*RUSSELL TOWNSHIP
NEWBURY TOWNSHIP
GEAUGA COUNTY*

TITLE SHEET

THIS PROJECT CONSISTS OF THE RESURFACING OF SR- 87 (KINSMAN ROAD) FROM SR- 306 (CHILlicoTHE ROAD) TO EAST OF AUBURN ROAD IN RUSSELL TOWNSHIP AND NEWBURY TOWNSHIP IN GEAUGA COUNTY.

Schematic Plan

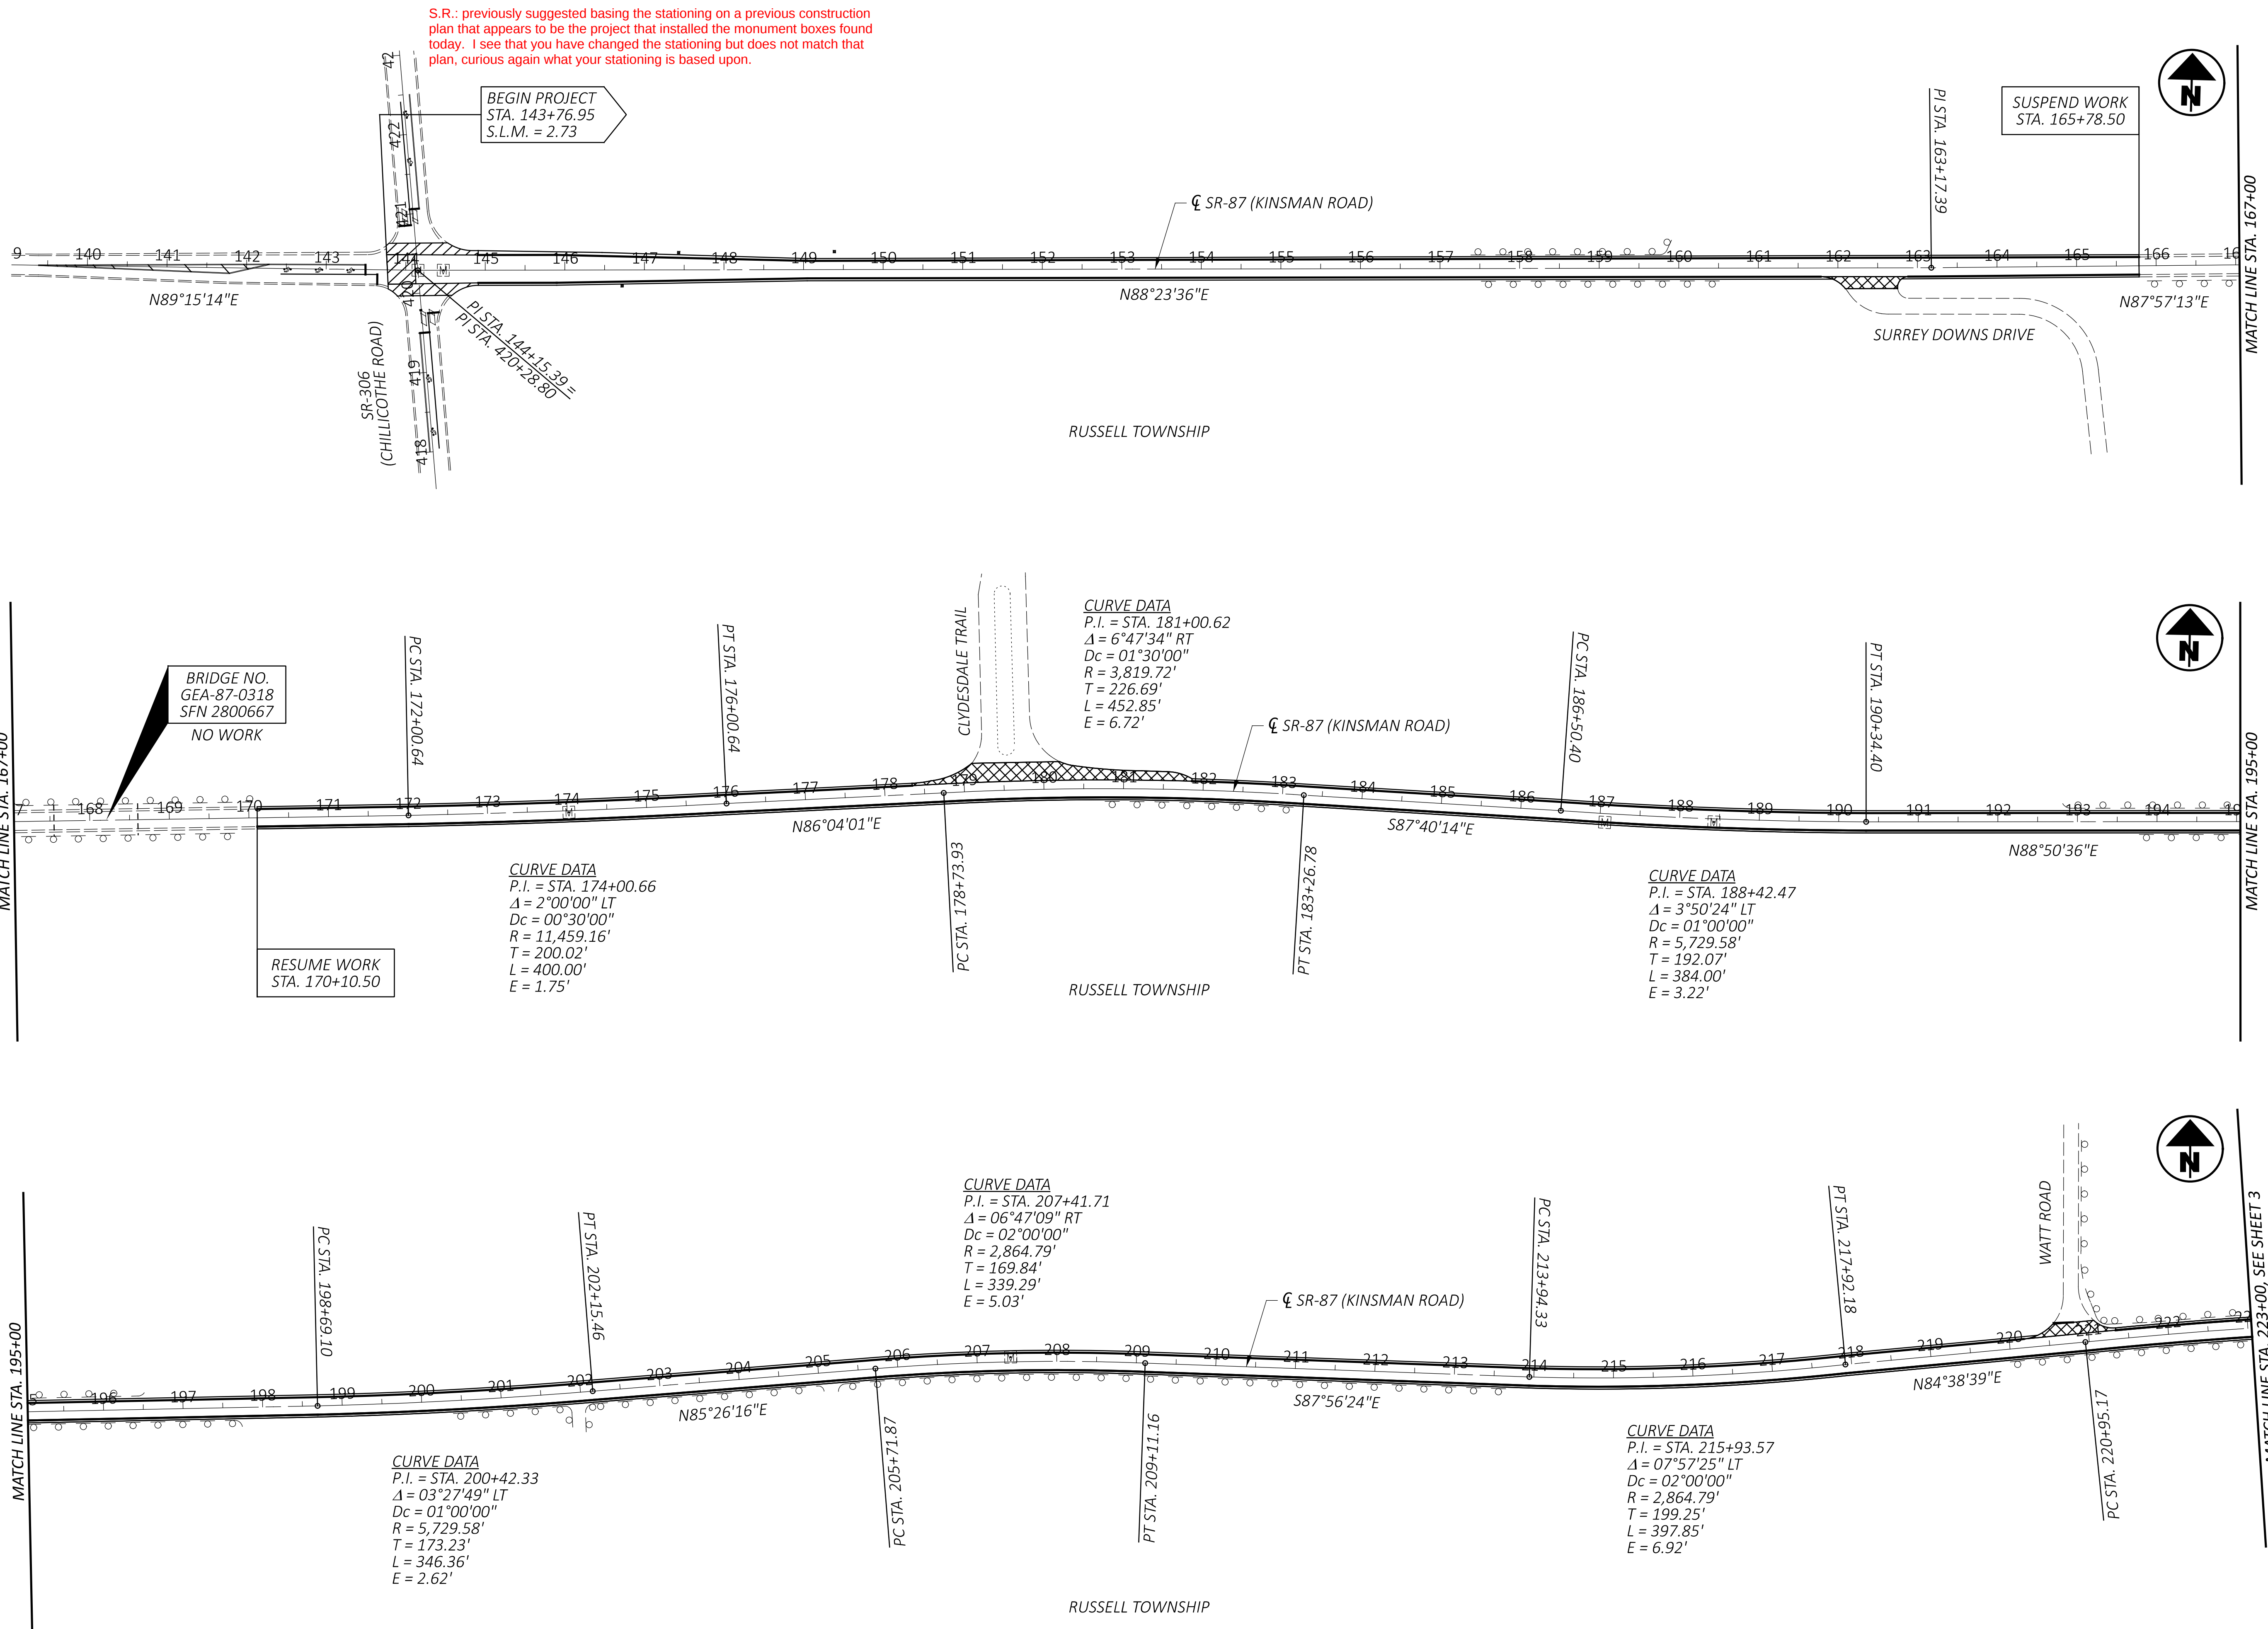
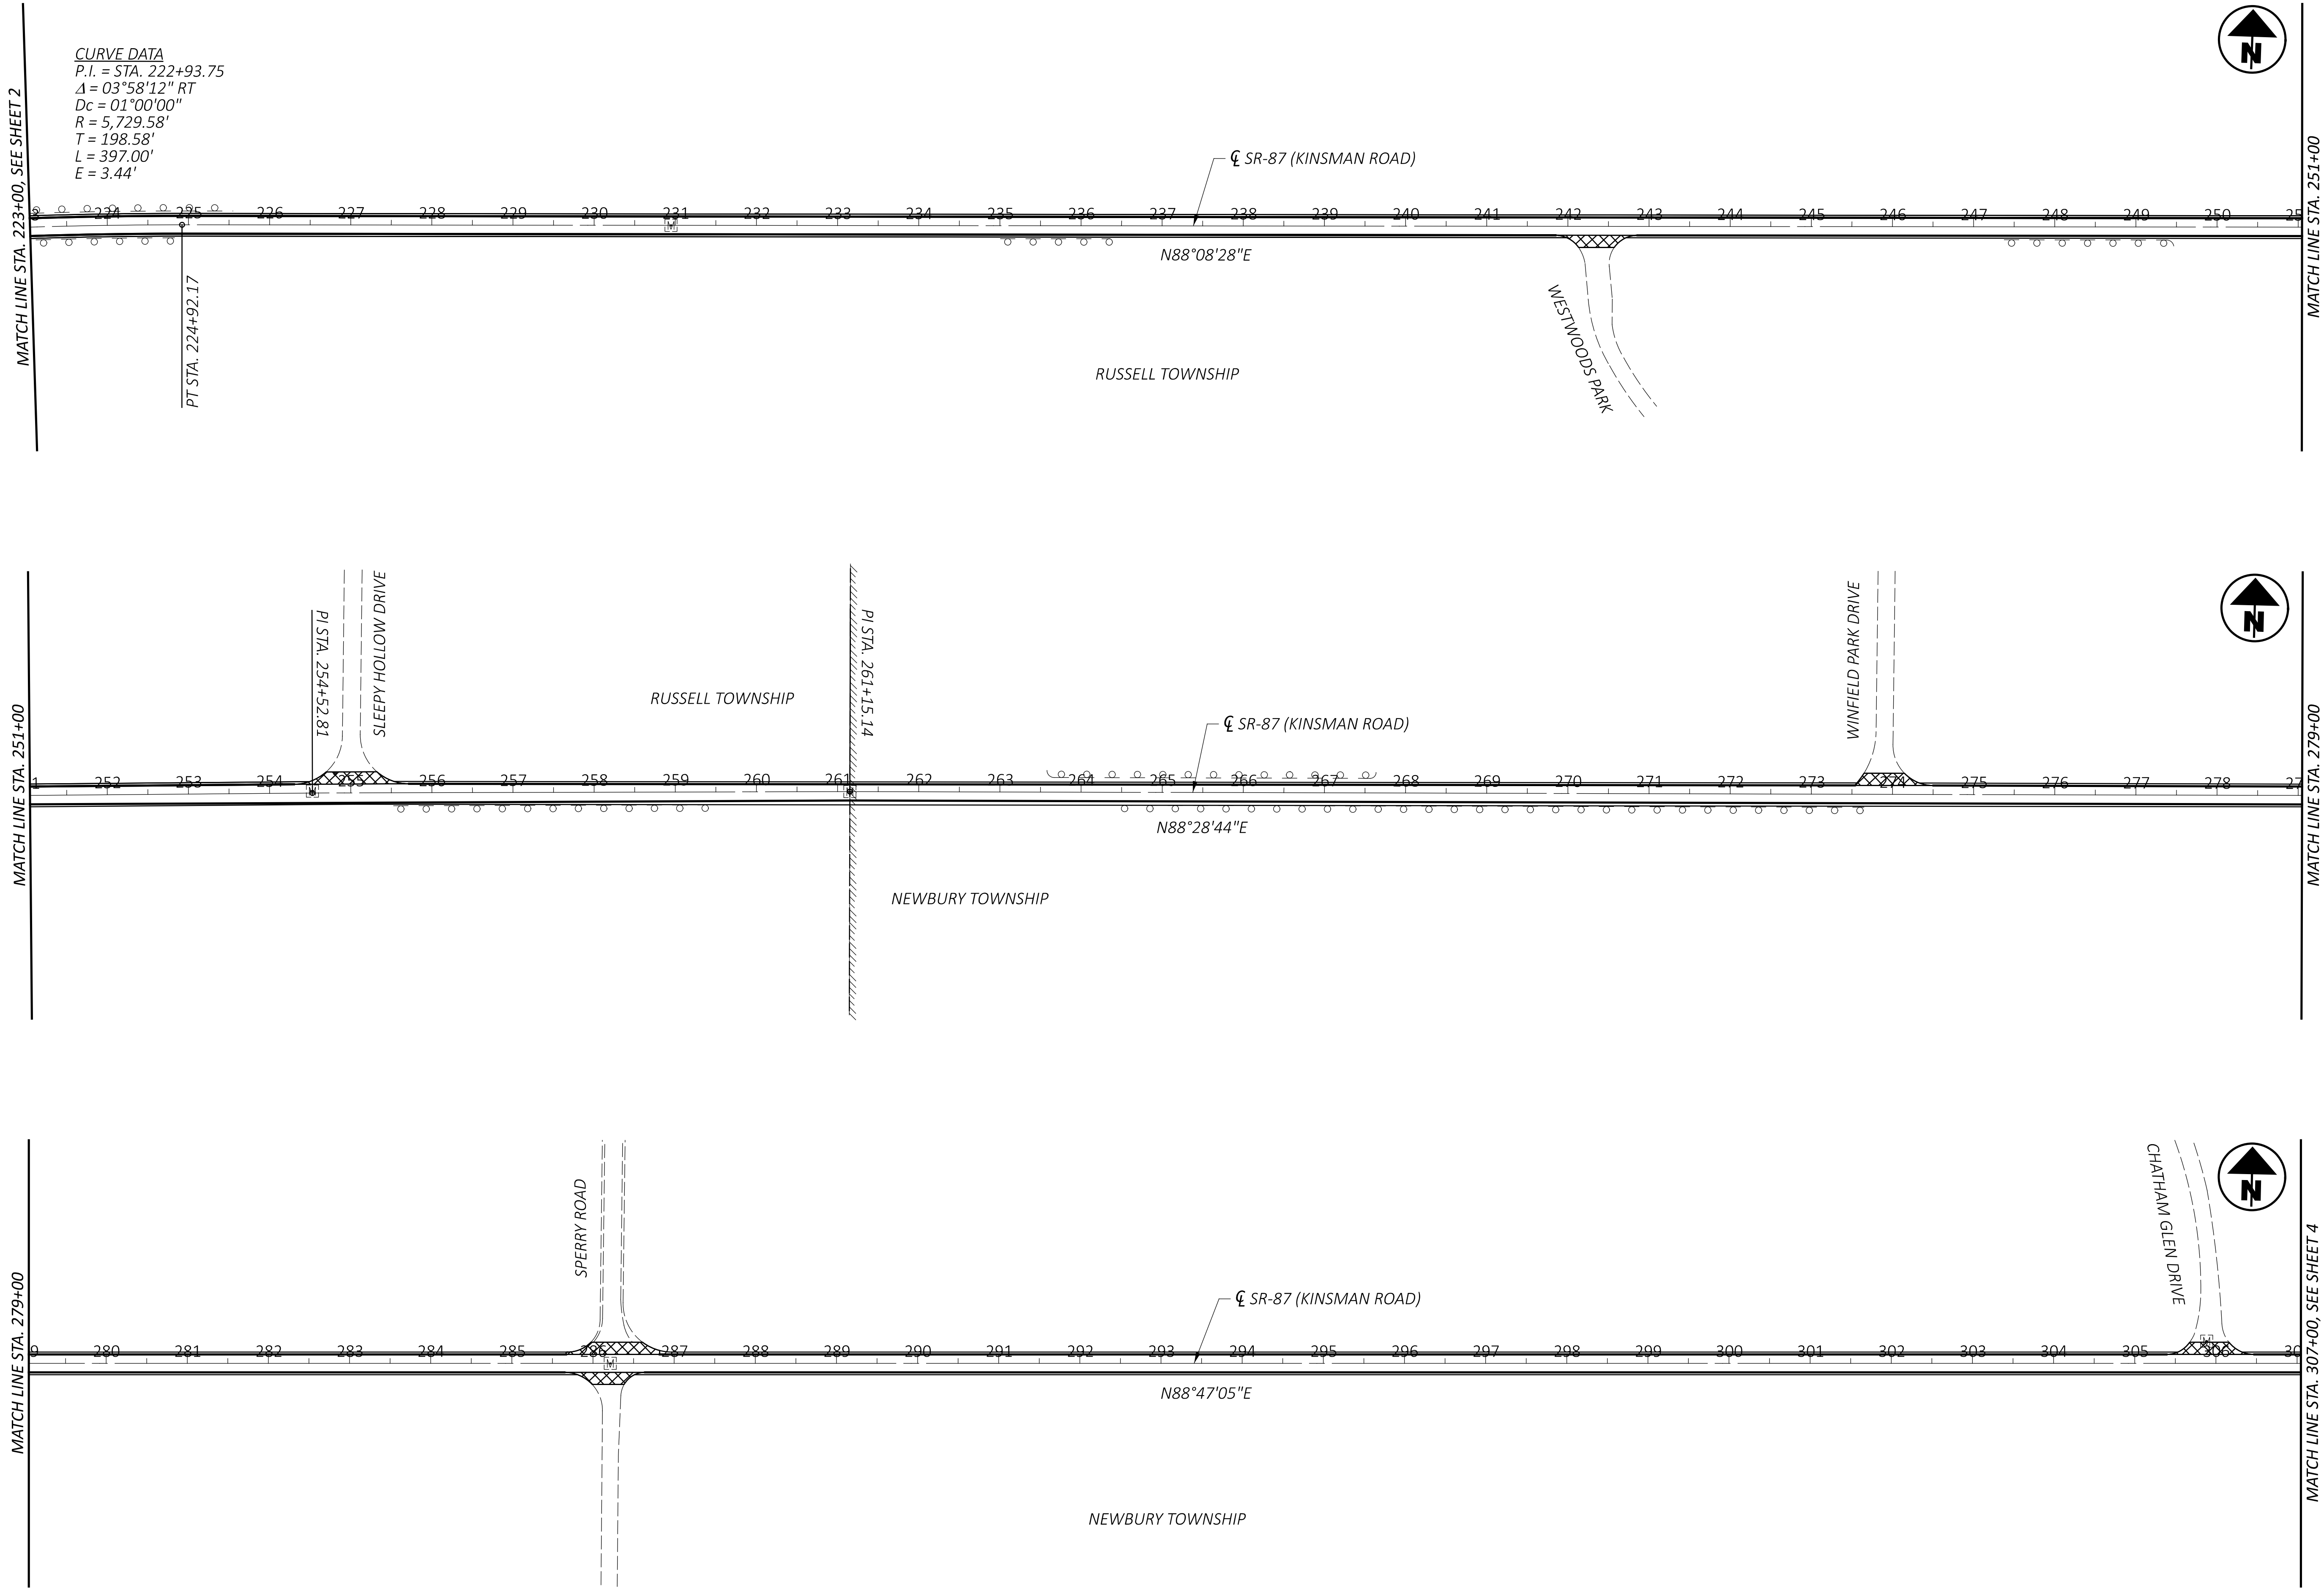
Remove
BP-3.2.
